UNITED STATES PATENT AND TRADEMARK OFFICE

10/622,621

Office Action Summary	Application No. 10/622,621	Applicant(s) WEBER ET AL.	
	Examiner CHRISTOPHER D. KOHARSKI	Art Unit 3763

DETAILED ACTION

**FIG. 2**

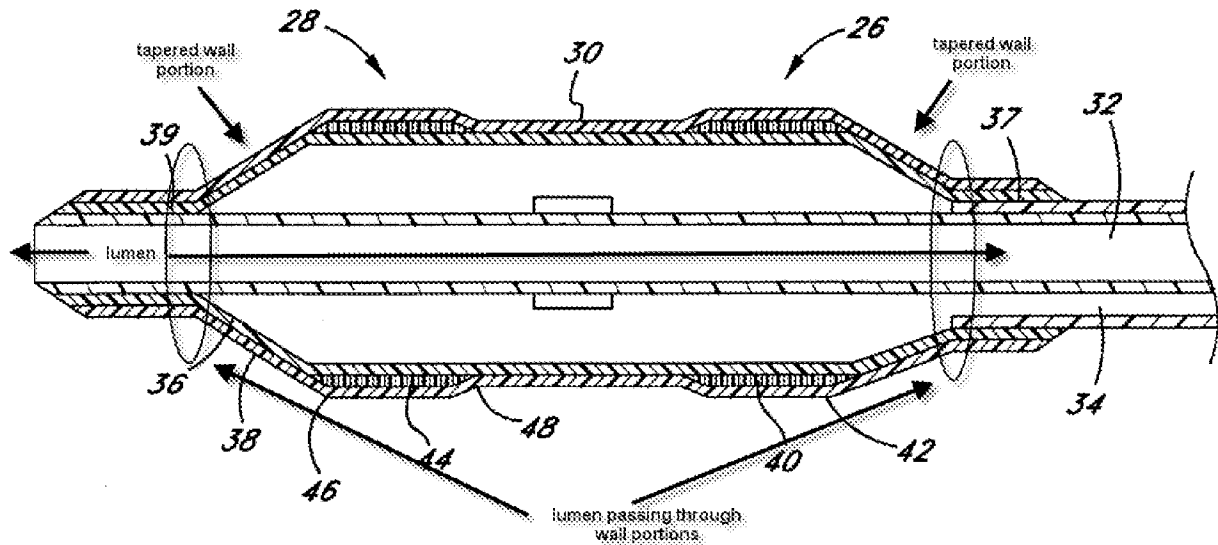
Regarding claims 27-29, 32-37 and 65-68, Crocker et al. discloses a medical balloon (18) having a longitudinal axis and proximal (26) and distal (28) ends, the balloon formed of a polymer material (col 6, ln 25-40), the balloon connecting to a coaxial shaft (37) at a proximal end thereof and connecting to the same or a different coaxial shaft at the distal end thereof (39), and having a central body wall portion (30) between each end spaced apart from the balloon ends and connected thereto by means of tapering proximal and distal wall (38, 42) portions, respectively, wherein the balloon further comprises a lumen (32) extending longitudinally therethrough, said lumen passing through the proximal and distal wall portions of the balloon (Figures 1-4).

Crocker et al. discloses a polymeric (cross-linked polyethylene, col 7, In 35-55) balloon and is a multi-layer polymeric film (39, 36, 38, 40, 42, 44) wherein a first (36, 48) and second layers are in adherent contact over a coplanar coextensive region defining an at rest and open configuration resulting in a change of surface area (Figures 2-3), with a layer comprising an elastomeric band (40, 44) that is stretched during the configuration change. Examiner asserts that the radiation cured polymer is a product by process limitation in which the resultant radiation cross-linked product is indistinguishable from the heat cross-linked polyethylene of Crocker et al.

Regarding claims 27 and 63, Examiner asserts that the balloon pictured in Figure 2 meets the claim limitations as claimed. The lumen (32) of Crocker et al. passes *through* the *tapering distal and proximal wall portions* (38, 42) of the balloon. Examiner asserts that the language as claimed is insufficient to overcome the prior art of record, the broadest reasonable of the definition of "extending through" is "passing or extending from one end, side, or surface to another" *"through."* *The American Heritage® Dictionary of the English Language. 2007.* Therefore Examiner asserts that the lumen (32) of Crocker et al. indeed passes through the tapering distal and proximal portions as claimed. As suggested in the previous office action Examiner suggests further clarification of the lumen axis or opening location in order to distinguish this lumens location.
